PLAN FOR PROPOSED IMPROVEMENTS

CONGESTION MANAGEMENT PROGRAM

DETECTION UPGRADE SET #2

DIVISION OF PUBLIC WORKS
CONGESTION MANAGEMENT PROGRAM
DETECTION UPGRADE SET #2
SHELBY COUNTY, TN.

FITE RD. AT U.S. HWY. 51
INTERSECTION LAYOUT

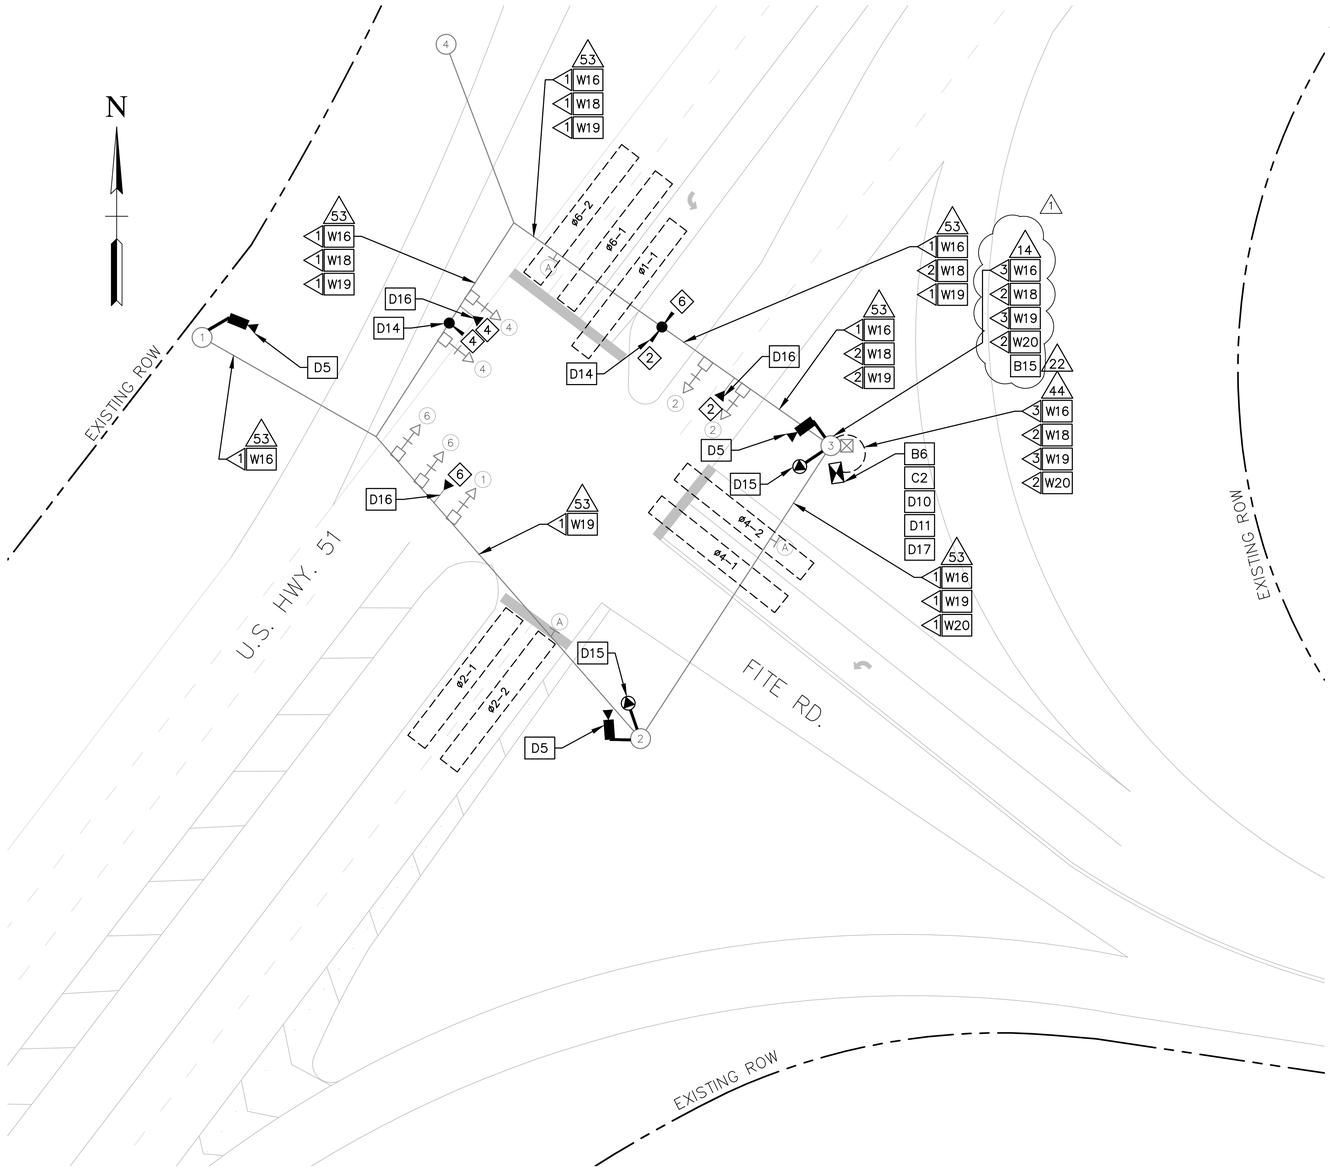
REVISIONS		
DATE	DESCRIPTIONS	APPROVED
10/2013	REVISED NOTES AND ADDED JUNCTION BOX

U.S. HWY. 70 AND BRUNSWICK RD.
INTERSECTION LAYOUT

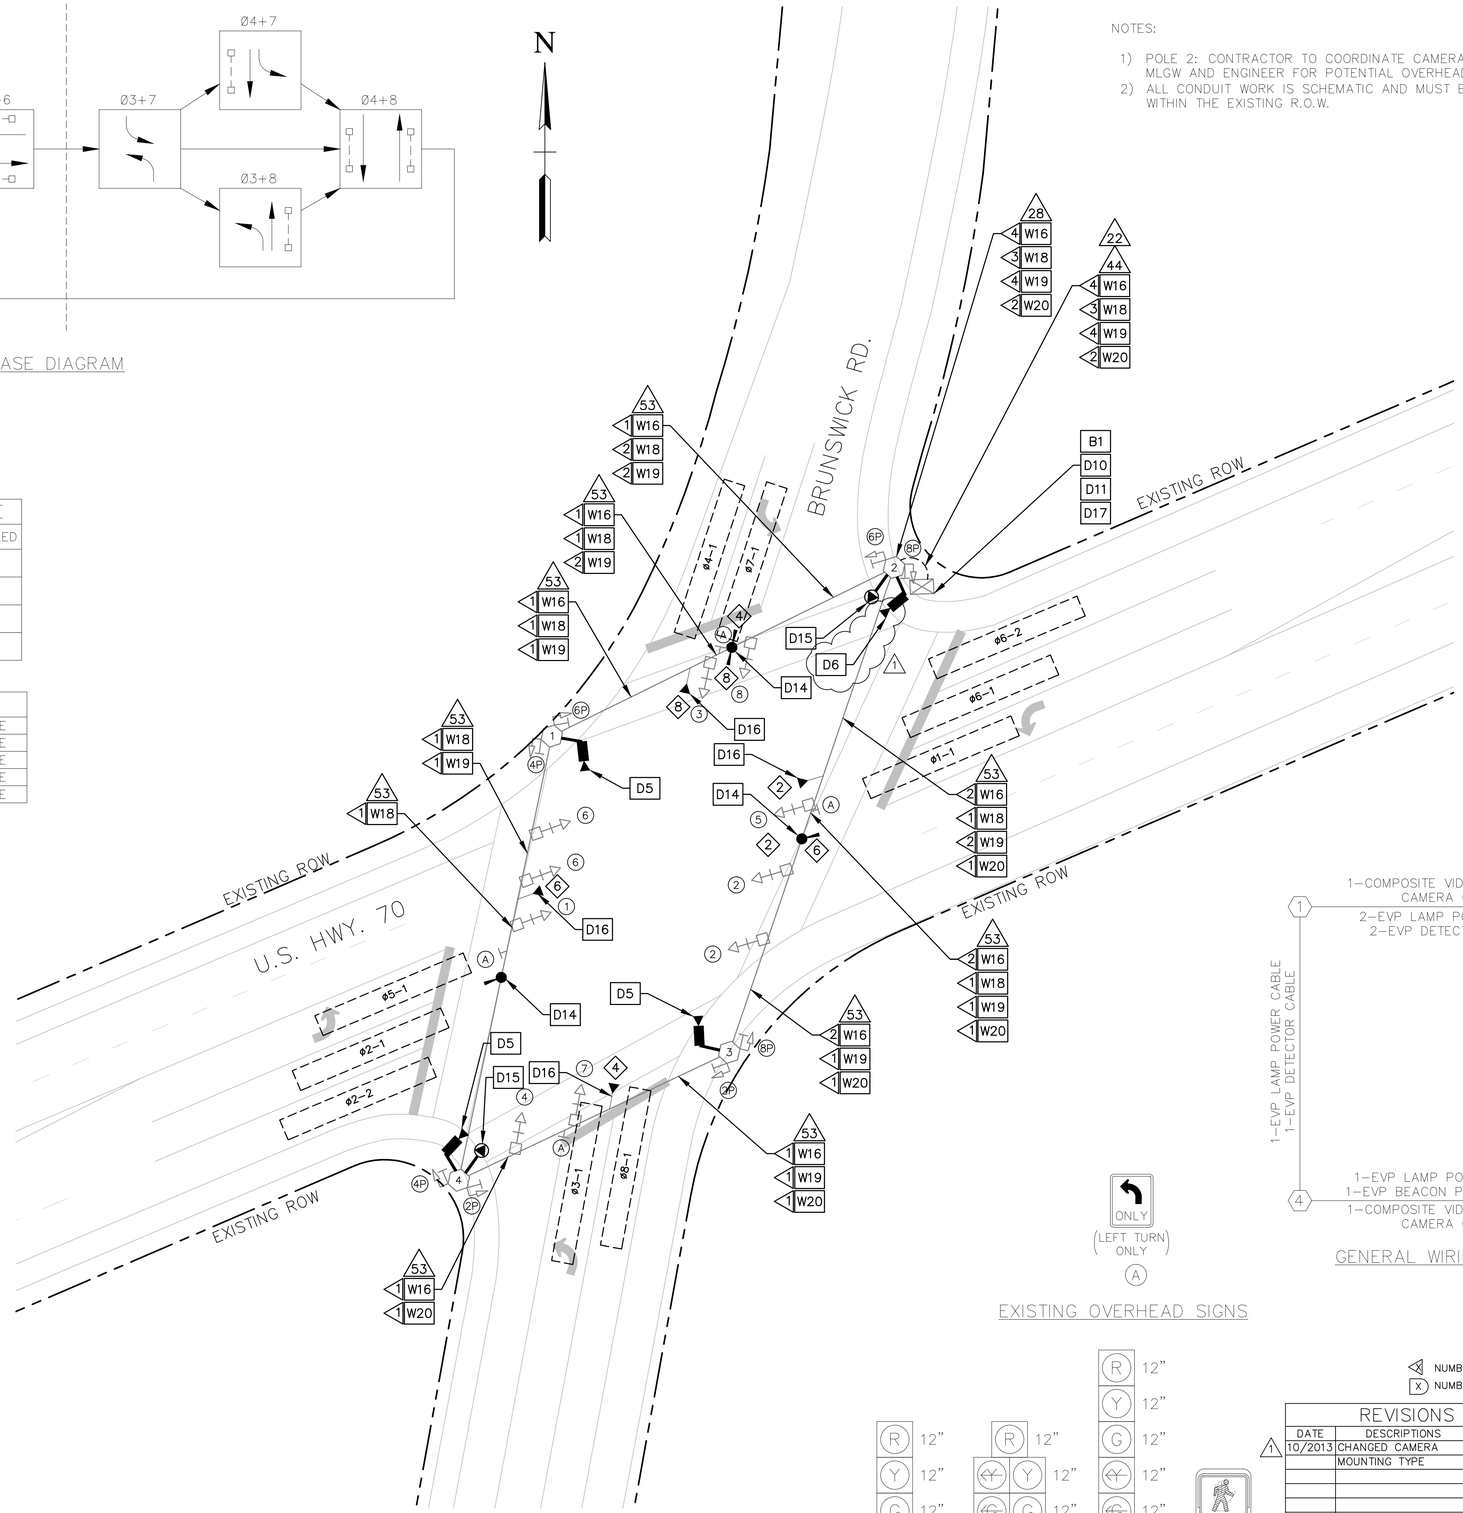
REVISIONS		
DATE	DESCRIPTIONS	APPROVED
1 10/2013	CHANGED CAMERA MOUNTING TYPE

'ANCED LOOP DETECTION DETAILS

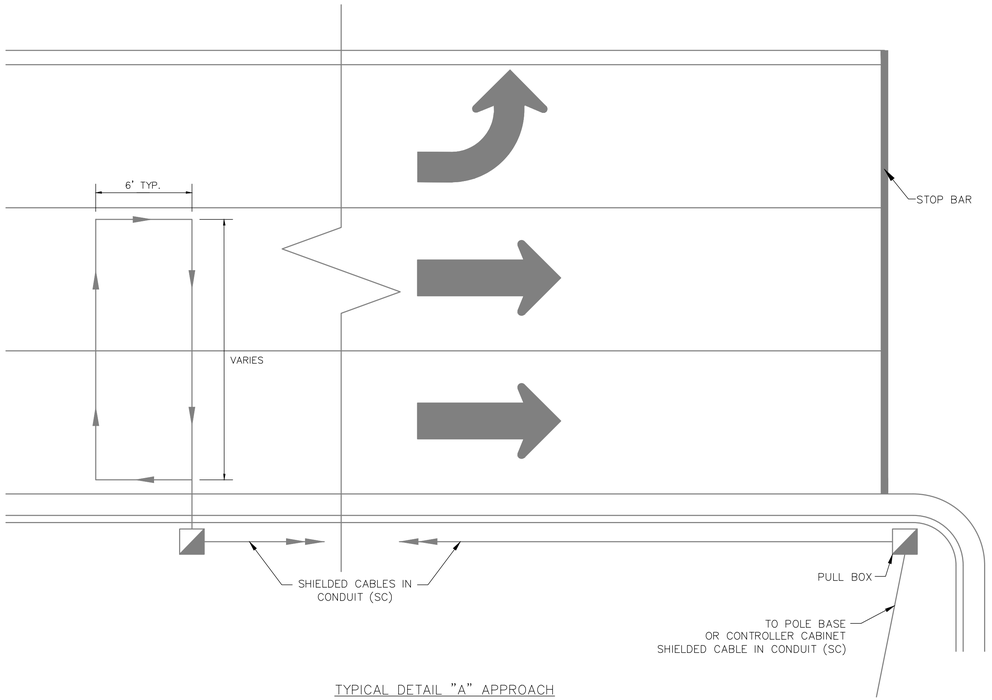
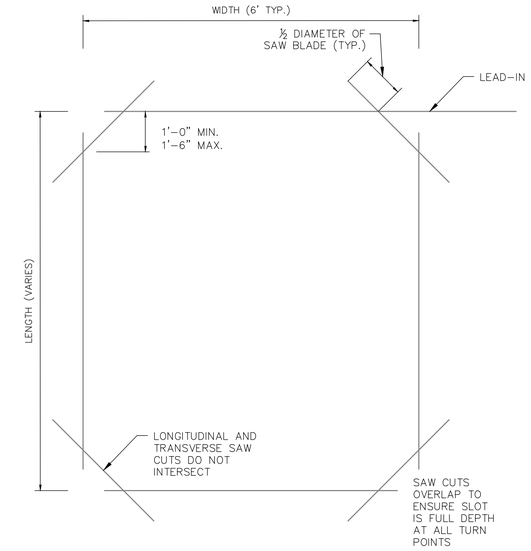
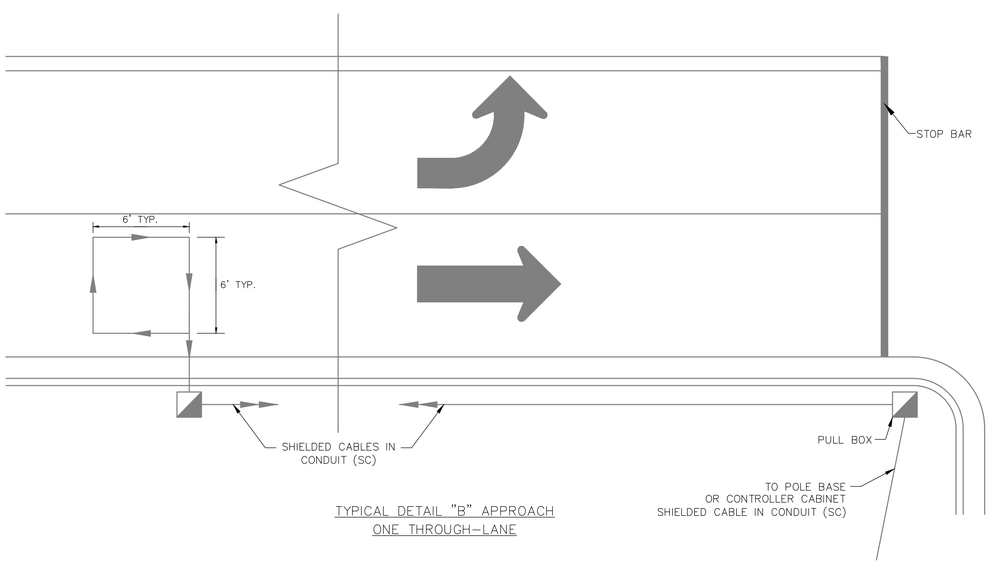
REVISIONS		
DATE	DESCRIPTIONS	APPROVED
1 10/2013	REVISED NOTES

1 (B) THE CONTRACTOR SHALL INSTALL LOOPS BY WET CUTTING A NARROW SLOT (⅜ INCH WIDE) IN THE ROADWAY SURFACE WITH A DIAMOND SAW. INSTALLING THE WIRE AND BACKFILLING WITH A SUITABLE SEALER. SAW SLOTS SHALL BE A MINIMUM OF 2" IN DEPTH.

1 (G) AFTER THE LOOP WIRES ARE INSTALLED AND ALL CHECKS SATISFACTORILY COMPLETED, THE SLOT SHALL BE BACKFILLED AND SEALED WITH AN APPROVED LOOP SEALANT TO WITHIN ⅛" OF THE PAVEMENT SURFACE. SURPLUS SEALANT SHALL BE REMOVED FROM THE ADJACENT ROAD SURFACE WITHOUT THE USE OF SOLVENTS. ASPHALTIC BASED SEALERS ARE NOT ACCEPTABLE.

1 (I) SPLICES SHALL BE PERMITTED ONLY IN PULL BOXES, POLE BASES, CONDULETS, OR CABINETS AND SHALL BE WATERPROOF.
